From: Scala, Mary Joy
Sent: Friday, February 20, 2015 10:19 AM
To: 'markwgreen@gmail.com'
Cc: 'Jeff Bushman'
Subject: BAR Action - Feb 17, 2015 - 608 Preston Ave

BAR 15-02-04

608 Preston Ave

**CITY OF CHARLOTTESVILLE
BOARD OF ARCHITECTURAL REVIEW
STAFF REPORT
February 17, 2015**

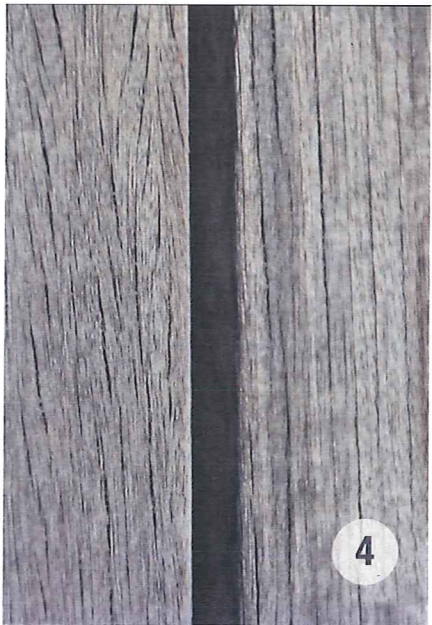
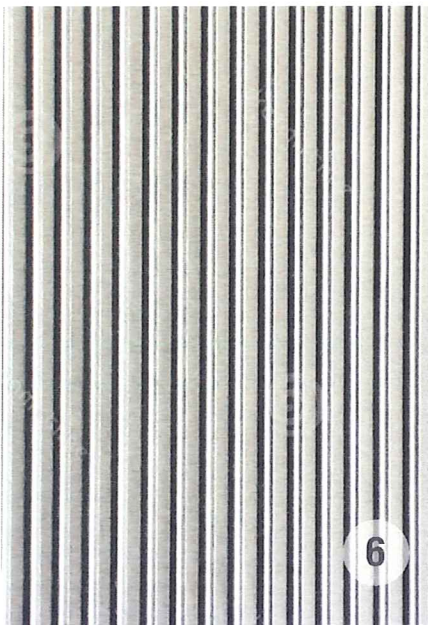
In 2008 the windows were proposed to be Jeld Wen Premium Wood, double hung, aluminum clad, in color Chestnut Bronze. The applicant should confirm the type of new windows and doors that are being proposed.

- 2** WINDOWS: WOOD, DOUBLE HUNG, ALUMINUM -CLAD IN CHESTNUT BRONZE COLOR
